5.4 Industry Standard Nondestructive Evaluations

6 Destructive Validation of Nozzle 63

Figure 5.17 Ultrasonic Data from Nozzle 63 as Obtained by WesDyne International. The image was acquired with a 5-MHz probe. The horizontal axis represents the nozzle circumference in units of degrees. The vertical axis represents the nozzle axis in units of millimeters.

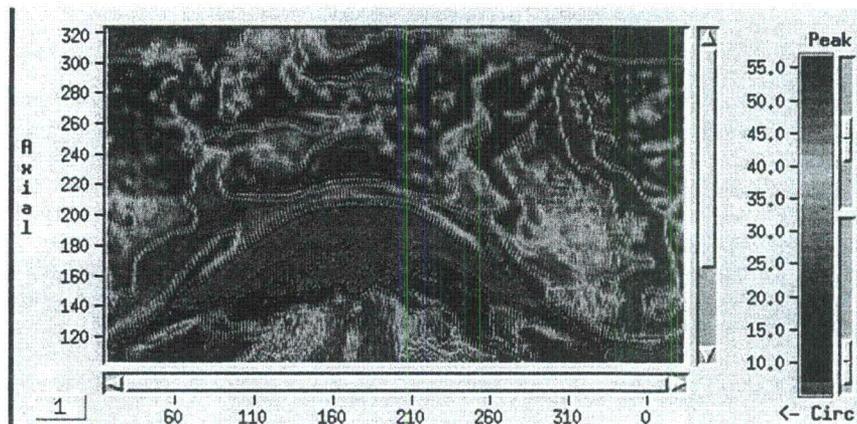
Comment [PG039]: We will talk further about this on the phone.

Comment [PG040]: What is the context for this examination? Was this done while the head was still on or after it was replaced?

Comment [PG041]: Remove this.

Figure 5.19 Eddy Current Data (WesDyne International) Showing Two Axial Flaws. The horizontal axis represents the nozzle circumference in degrees. The vertical axis represents the nozzle axis in millimeters.

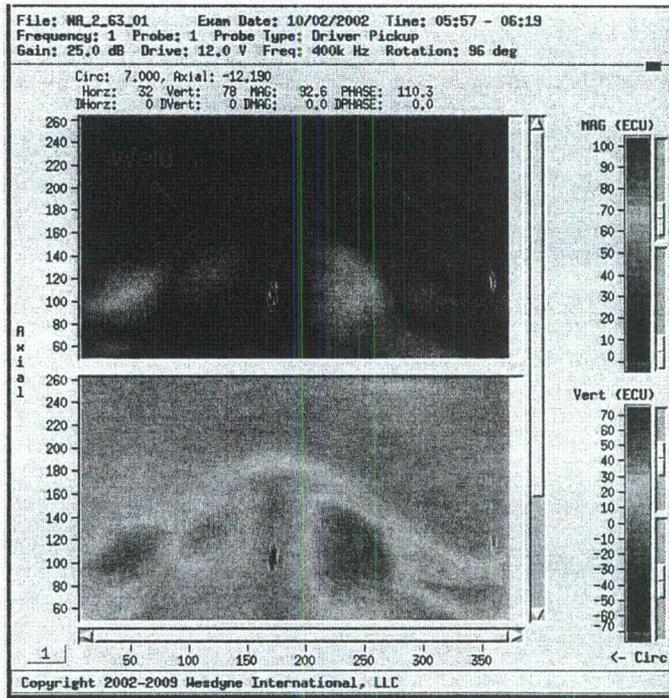
Comment [PG042]: What is the difference between the top and bottom image?

Figure 6.1 Three Blade Types were Utilized to Section the RPV Head and CRDM Nozzle. From left: fine tooth blade, coarse tooth blade, and carbide grit blade.

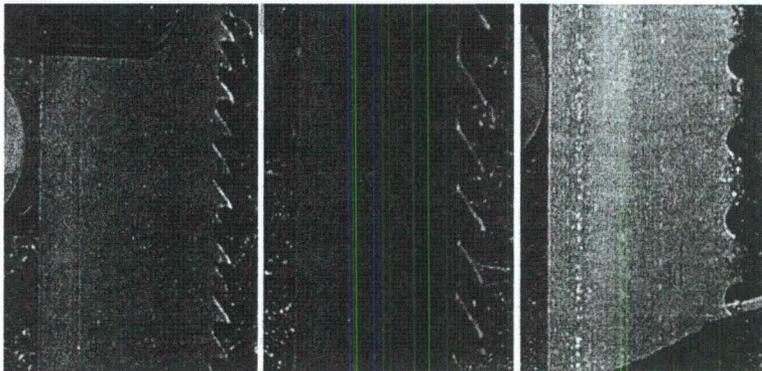
Comment [PGO44]: Section on cutting can be substantially shortened. Only need a few pictures and paragraphs to describe what we did: 1 paragraph/figure on size reduction cut, 1 paragraph/figure on bisection cut, 1 paragraph/figure on weld removal cut.

Comment [PGO45]: Remove this figure.

Figure 6.2 Size Reduction Cutting Activity

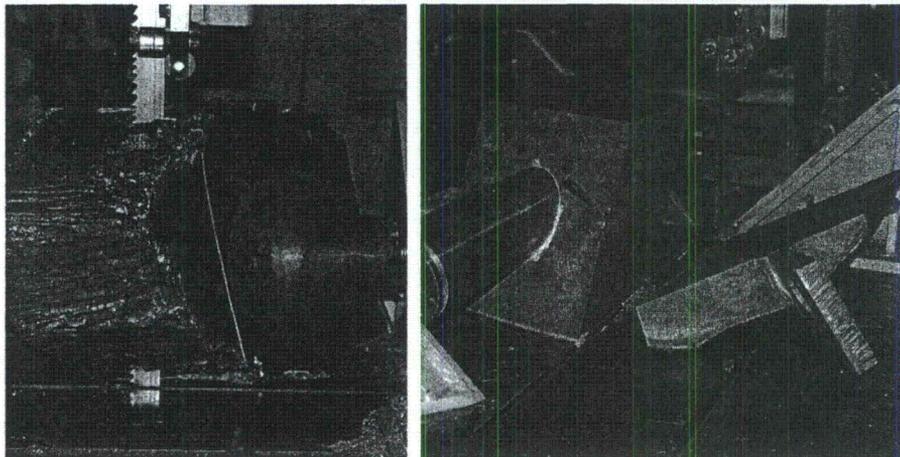
Comment [PGO46]: Can keep this figure.

Figure 6.3 Start of the Dissection Cut

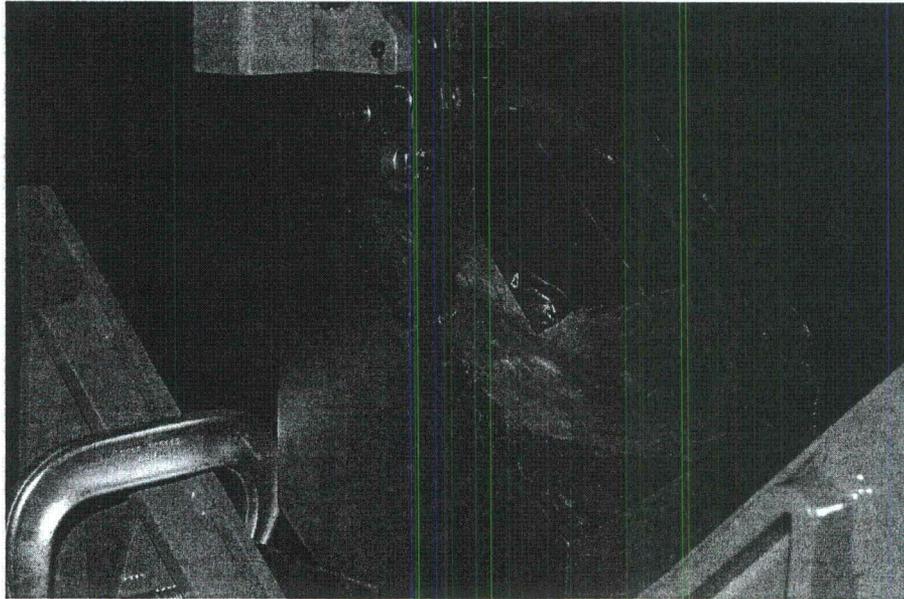
Comment [PGO47]: Keep this figure.

Figure 6.4 Abrasive Carbide Blade Progressing Through the Hard Spot

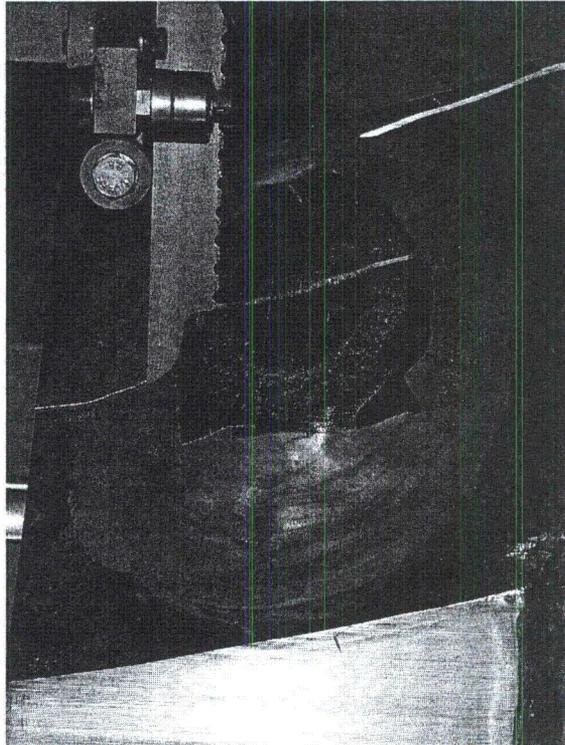
Comment [PG049]: Remove this figure.

Figure 6.5 Nozzle 63 Assembly Cut in Half by Dissection Cut

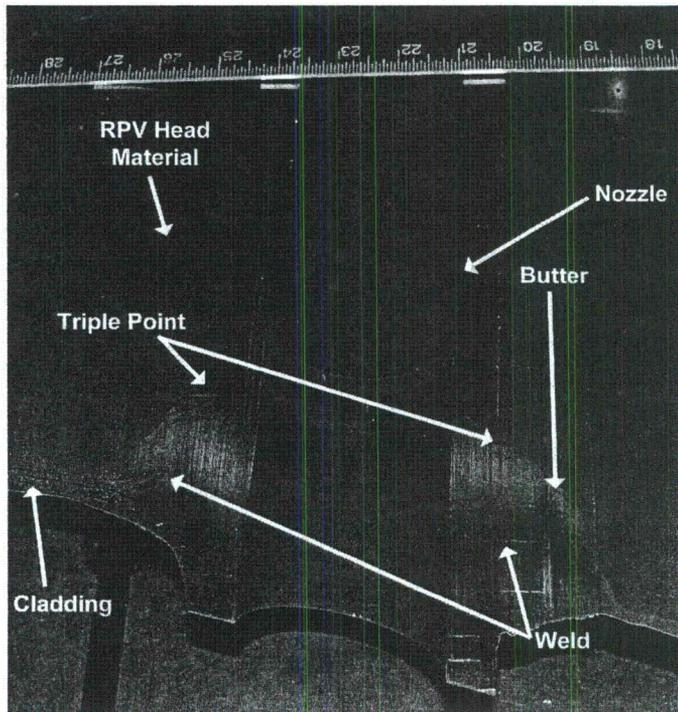
Comment [PG050]: Keep this figure. Remove all labels except RPV head and weld. Draw a line on this figure to show where the weld removal cut was made.

Figure 6.6 J-groove Weld Removal Cut Line Placement

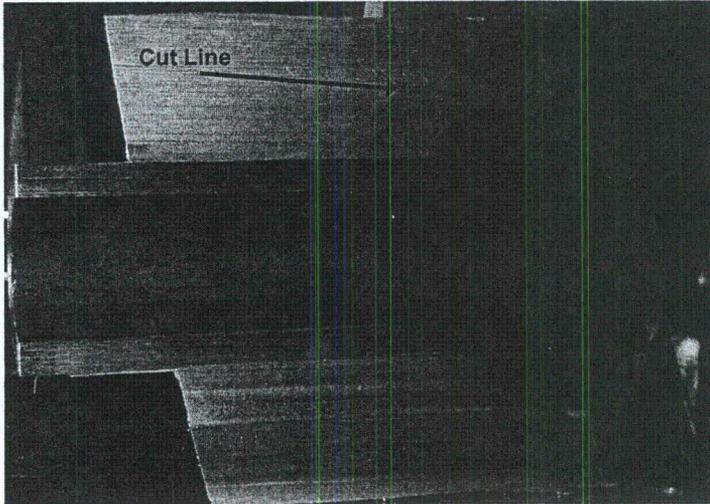
Comment [PG051]: Remove this figure.

Figure 6.7 J-groove Weld Cut on the High Side

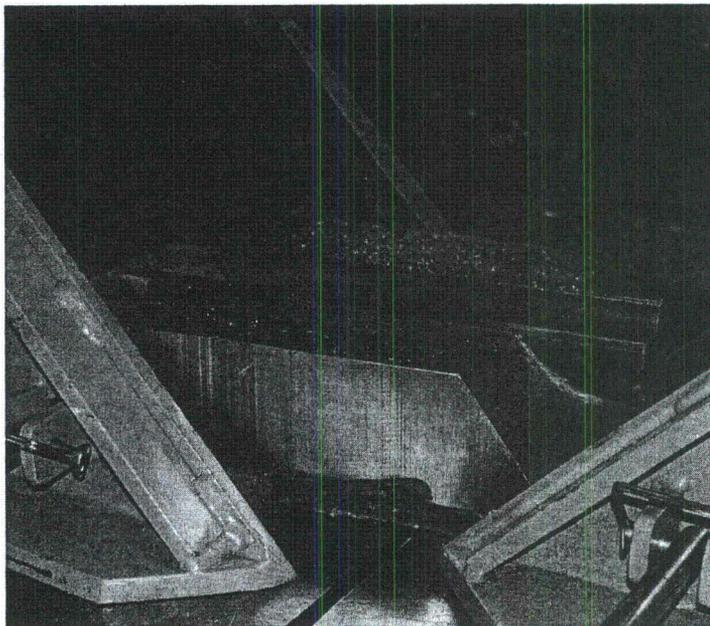
Comment [PG052]: Remove this figure.

Figure 6.8 Abrasive Blade Cutting Through the Nozzle with a HEPA Vacuum Nozzle

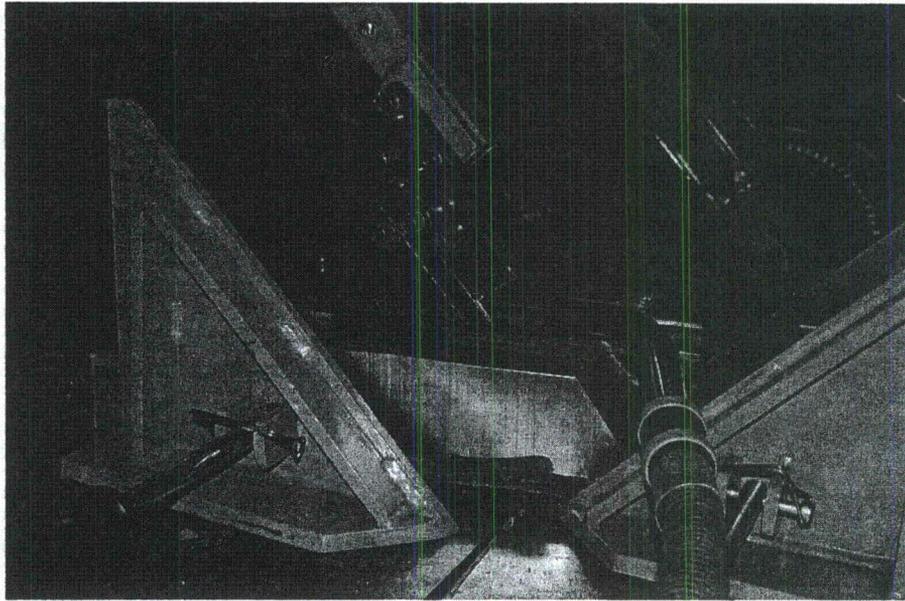
Comment [PG053]: Remove this figure.

Figure 7.2 RPV Head Surface. The red line marks the interference fit region.

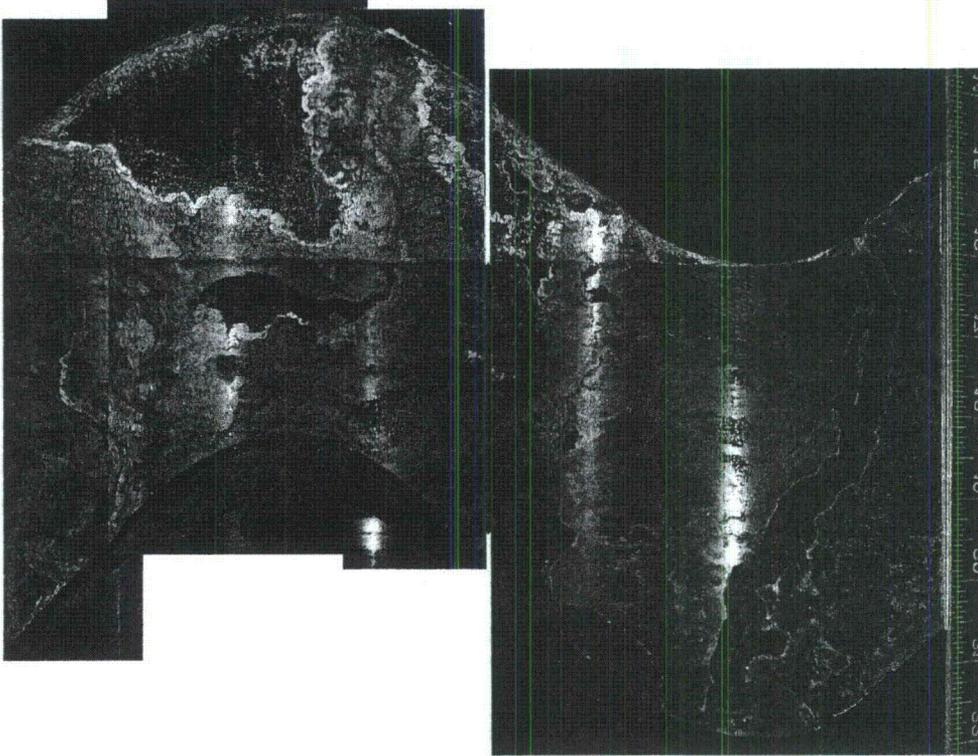
Comment [PG054]: You may identify the leak path with an arrow or something on the figure.

Comment [PG055]: See comment on Figure 7.3. This picture should be on the same page as the UT data so that they can be easily compared.

Figure 7.3 Ultrasonic Data Overlaid on RPV Head Photograph with Opacity Varying from 10 to 60%, Top to Bottom

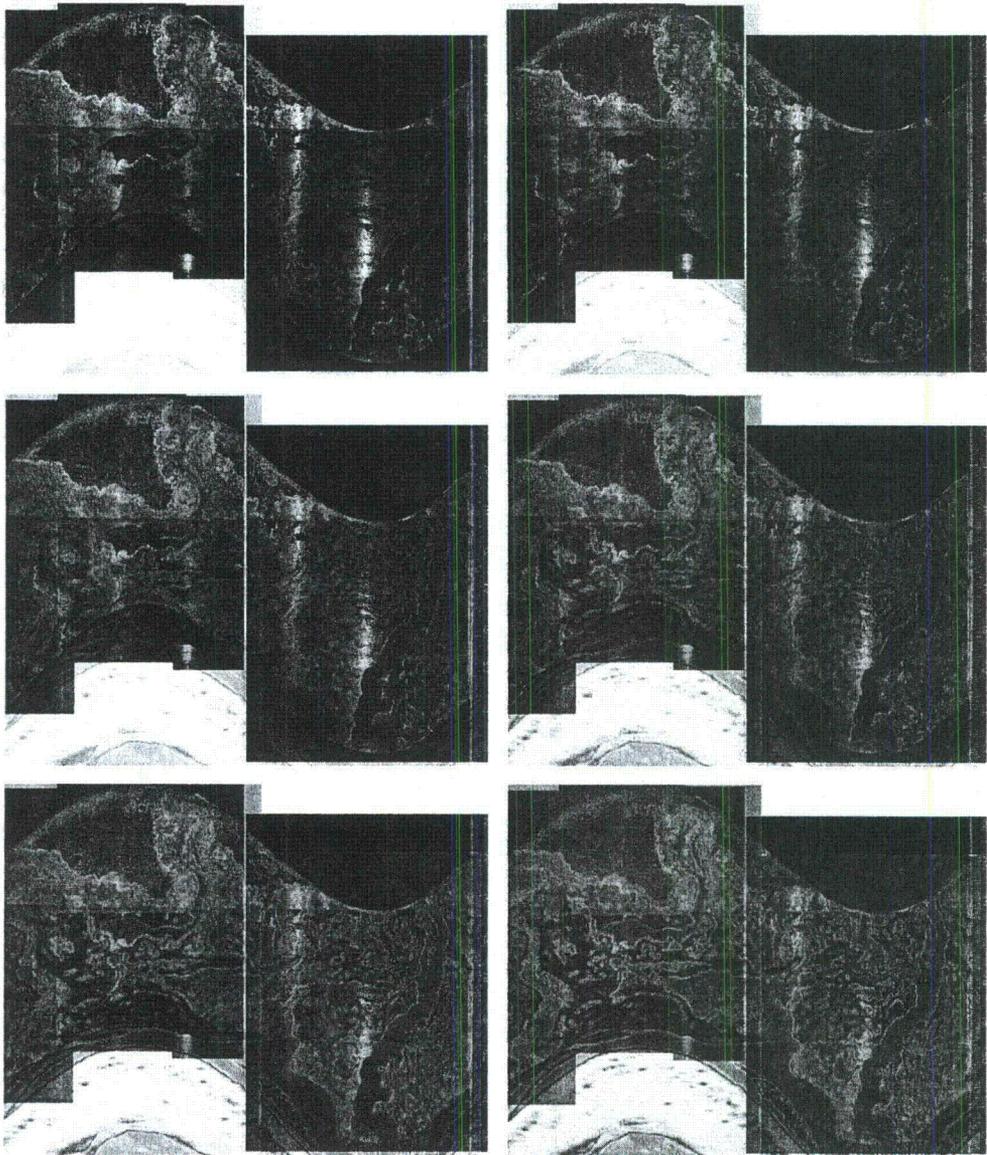
Comment [PG056]: You don't need all the overlaid images. We do need on the same page Figure 7.2 and the UT data on the same size scale next to each other, or one on top of the other.

Figure 9.1 Photograph of the RPV Head Material with Boric Acid Measurement Points

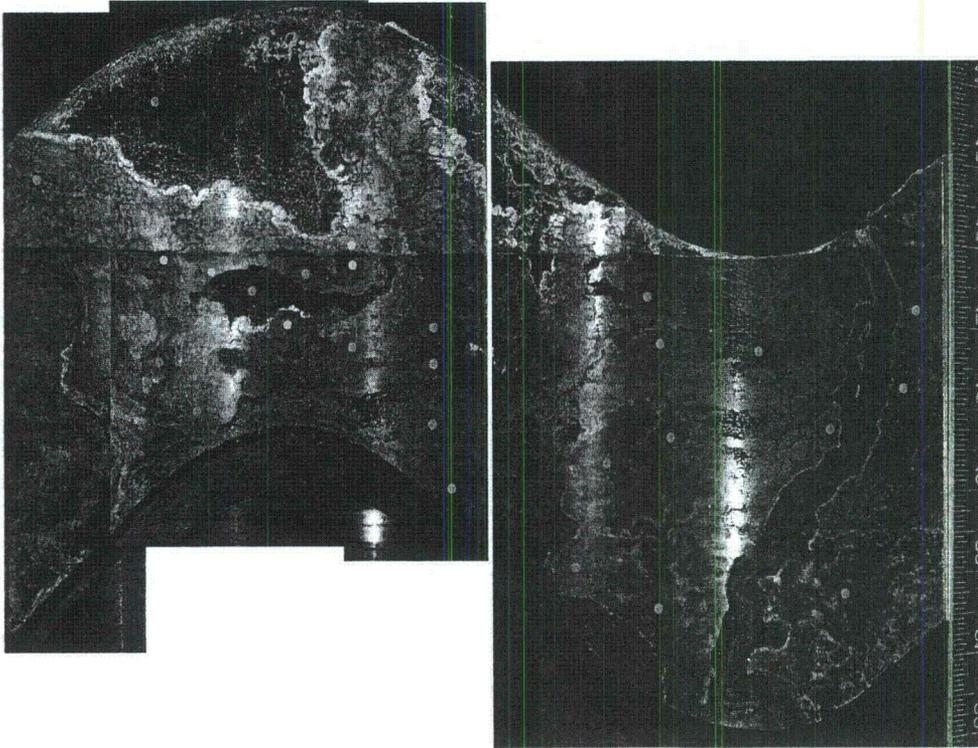
Comment [PG059]: This needs to be restated because it is confusing as written. Particularly because the tricolor image used blue, light blue, and white to distinguish the regions. Should say something like, "Red dots represent measurement sites in and around the main and suspected leakage paths. Yellow dots represent measurement sites... Green dots represent measurement sites..."

Comment [PG060]: State what the dots are and the significance of the color scheme. Mark the span of the interference fit.

Figure 9.3 Boric Acid Thickness Values in Microns

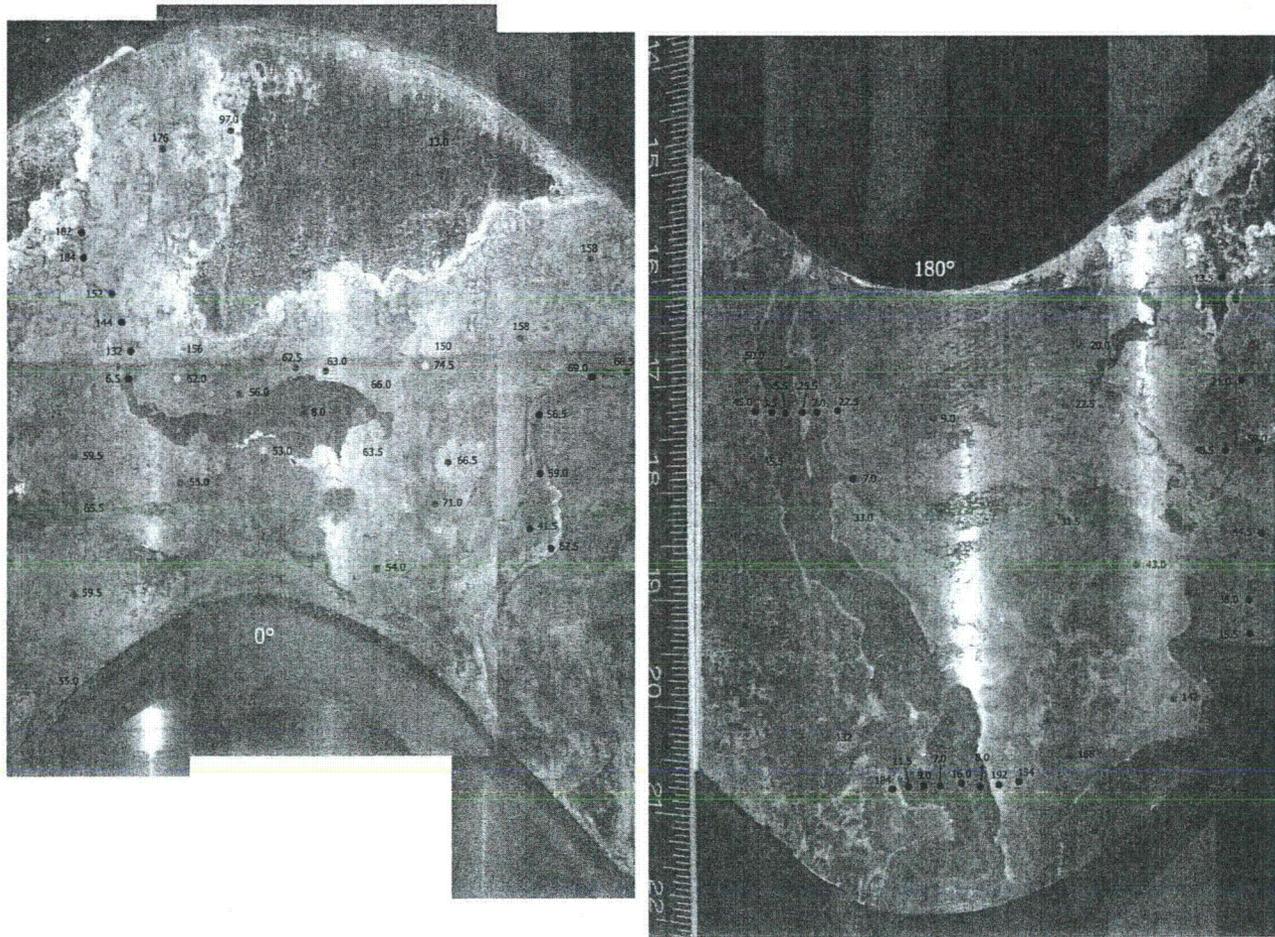
Comment [PG063]: The numbers are small and hard to read. Is there a way to make larger?

Figure 9.4 Ultrasonic Amplitude as a Function of Boric Acid Thickness from Points in the Interference Fit Region

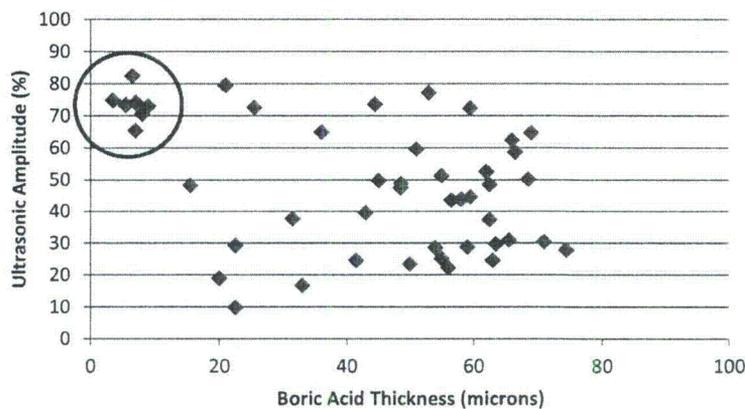
Comment [PG064]: Remove figure.

Figure 9.5 Ultrasonic Amplitude as a Function of Boric Acid Thickness from Points Above and Below the Interference Fit Region

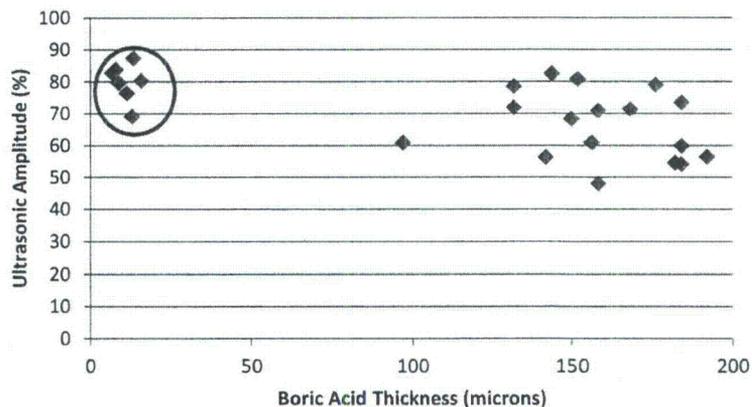
Comment [PG065]: Remove figure.

Figure 9.6 Overlay of Ultrasonic Image on the 70 Measurements Points

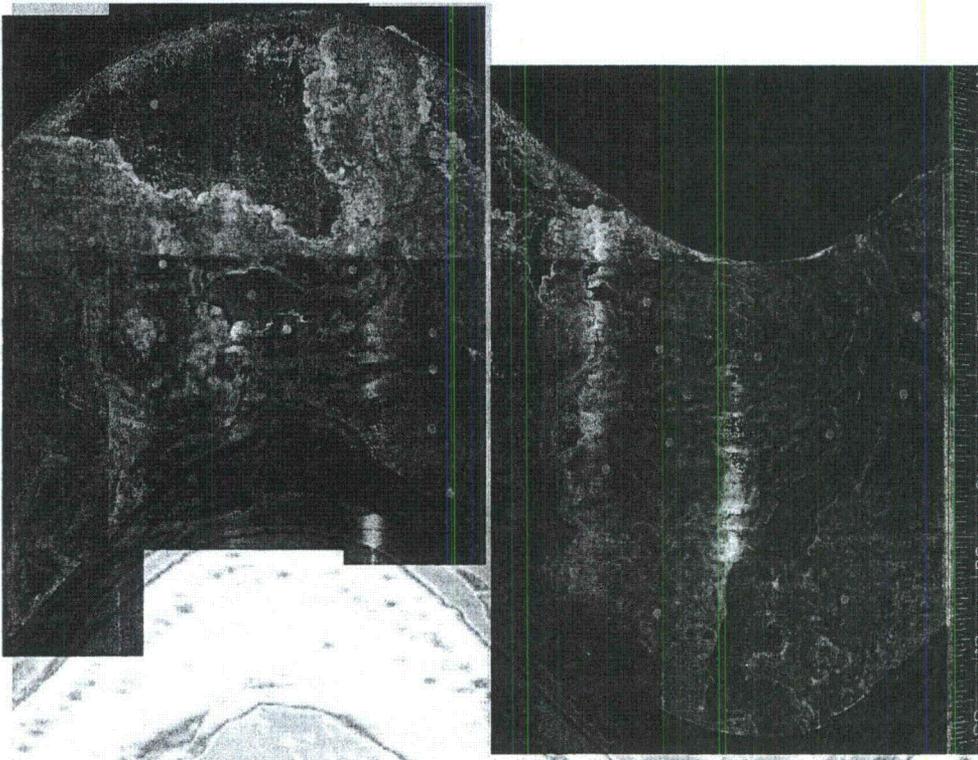
Comment [PG066]: Remove figure.

Figure 9.7 Eight Areas Selected for Boric Acid Thickness Measurements on Cross-Sectional Slices of Microset Replica

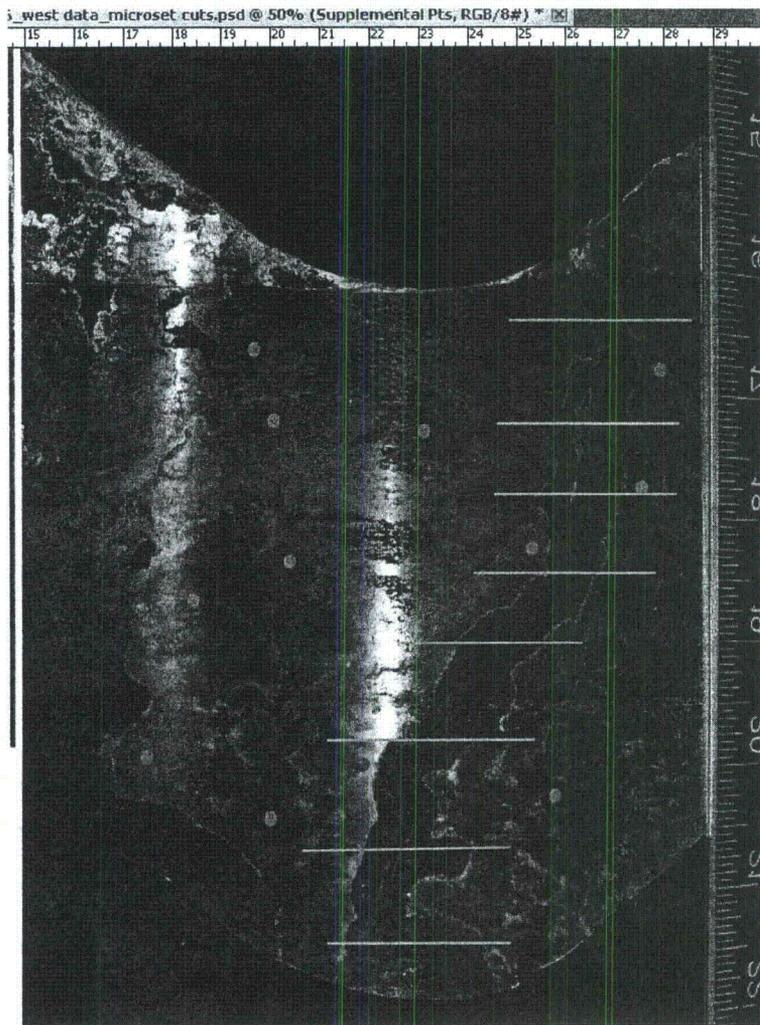
Comment [PG073]: Remove dots from figure except those for the horizontal line measurements.

Figure 9.9 Eddy Current Thickness Gage and Microset Thickness Measurements of Boric Acid Comparison

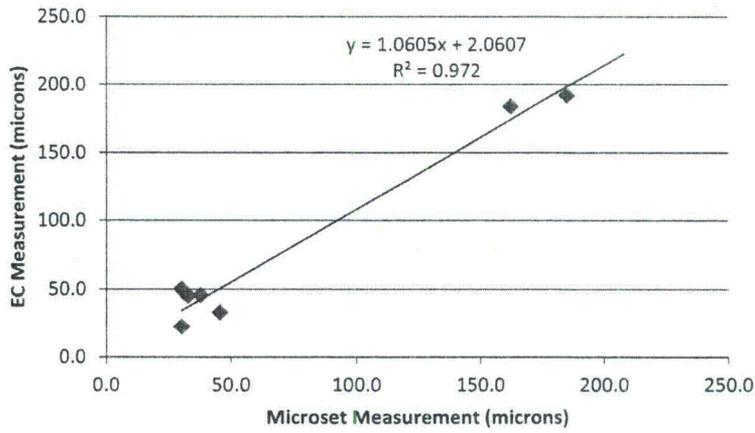
Comment [PG074]: Use a table to compare the measurements instead of plot.
